6457	Antoinette Drive	Mentor
ADDRESS	STREET	CITY
7	Leroy Center Subd.	L 87
SUBLOT No.	SUBDIVISION NAME	VOL. PAGE
Leroy		
TOWNSHIP	TRACT-LOT	CITY

CHECK LIST

#94-216

TYPICAL CURTAIN DRAIN CROSS SECTION

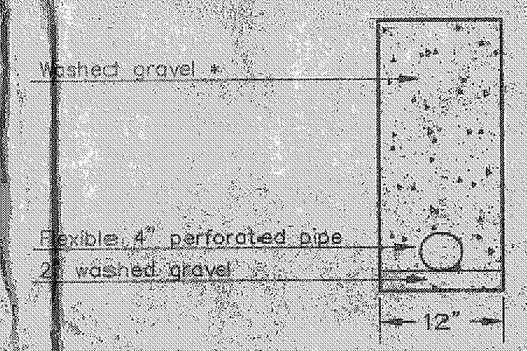
* The curtain drain must be 6 inches deeper than the deepest ET/Leaching trench bottom.

EVAPOTRANSPIRATION TRENCH SECTION

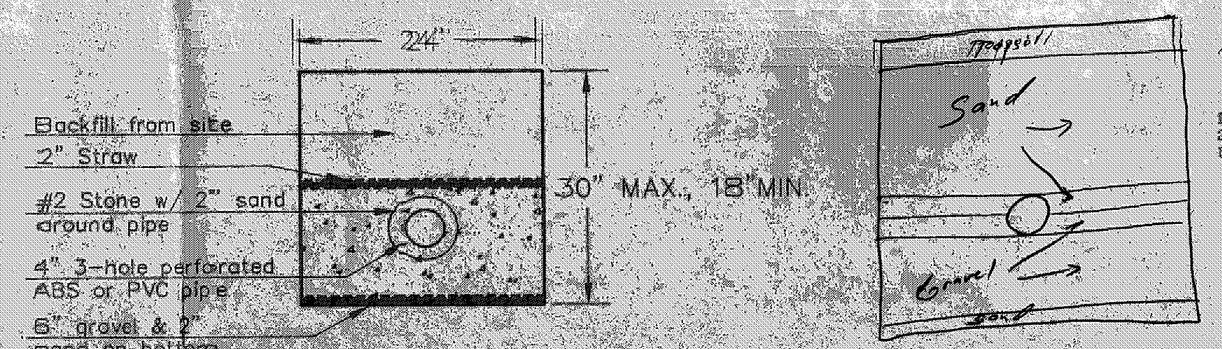
A. To be brought to finished grade
1. Septic tank manhole covers
2. Splitter box cover
3. Distribution box cover

B. No footer drains or downspouts to be discharged into septic tanks
C. All waste water to be discharged into septic tanks

All noted

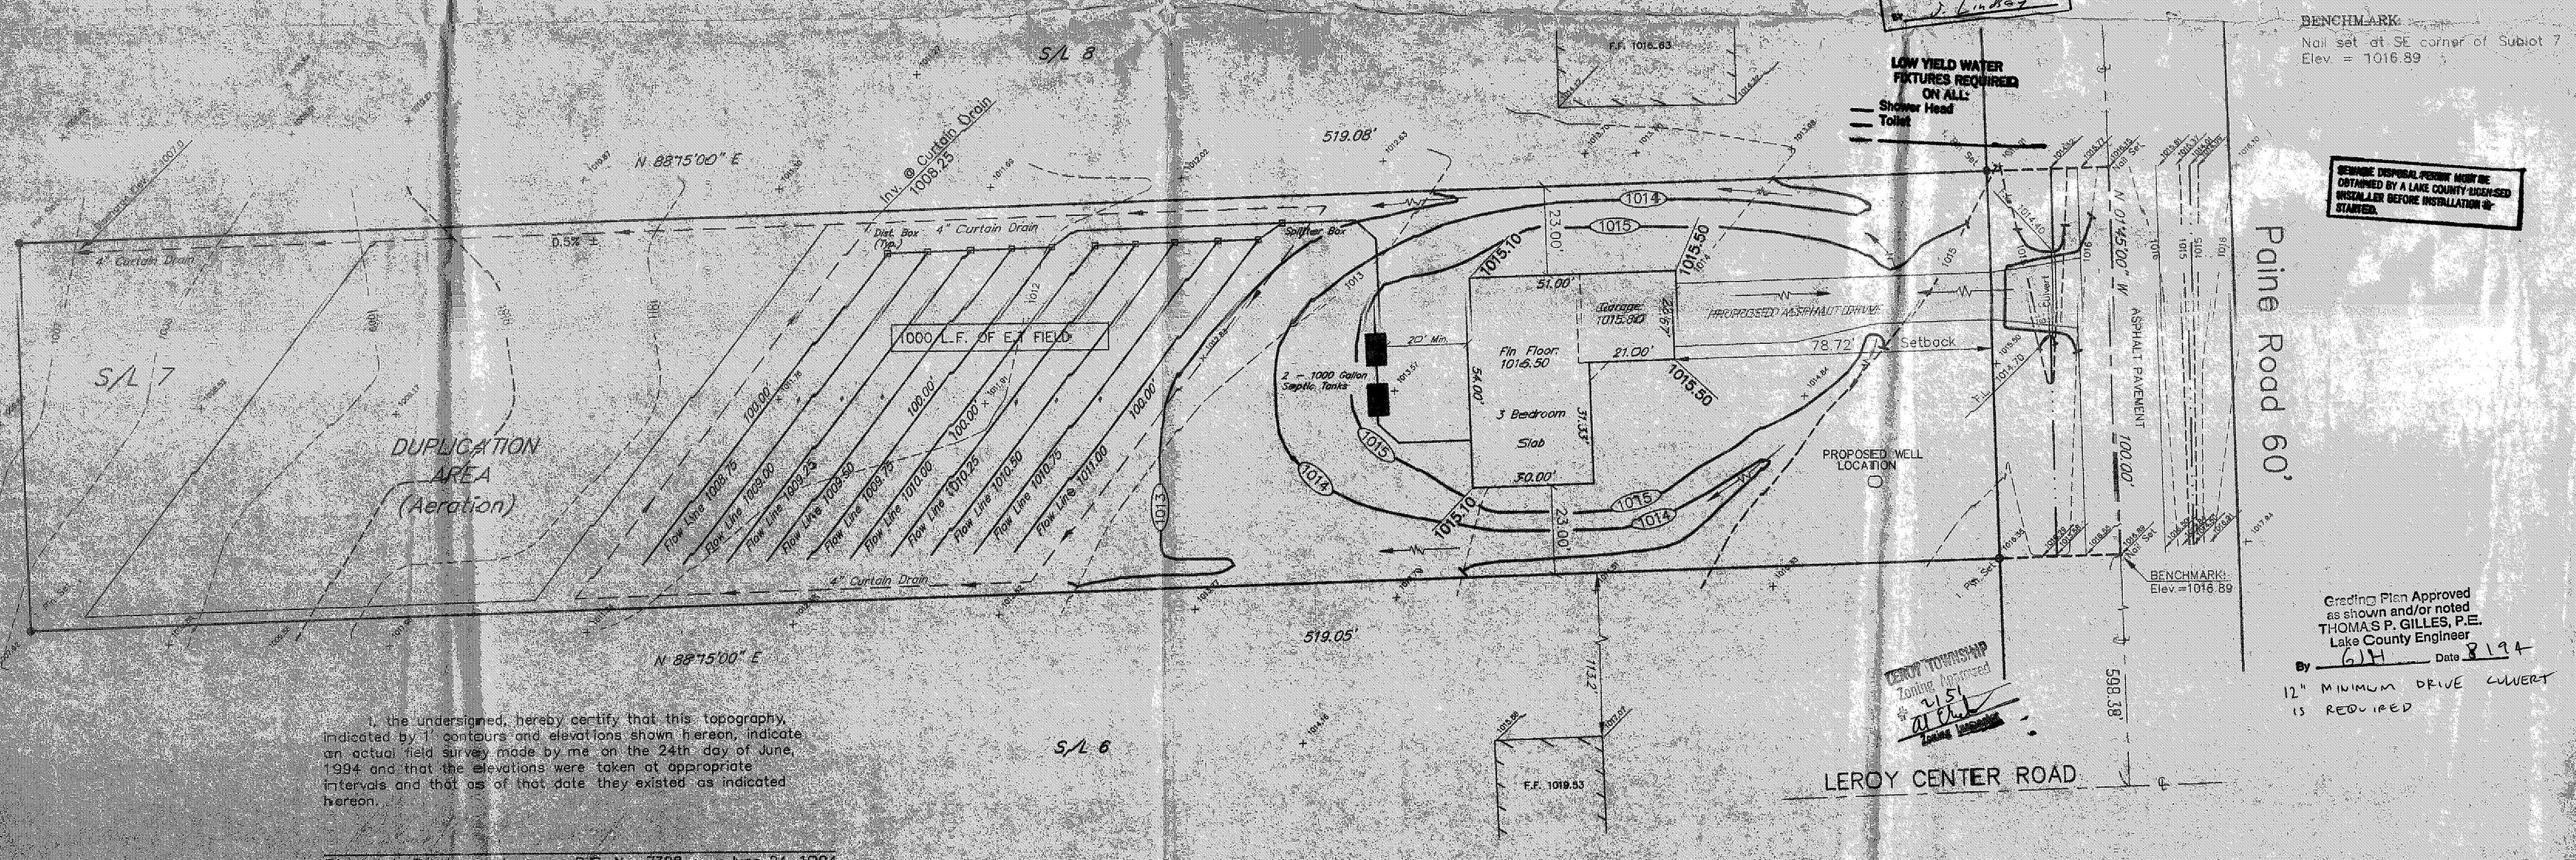
Grading Plan Approved as shown and/or noted
THOMAS P. GILLES, P.E.
Lake County Engineer
By GH Date 8-19-94
12" MINIMUM DRIVE CULVERT IS REQUIRED
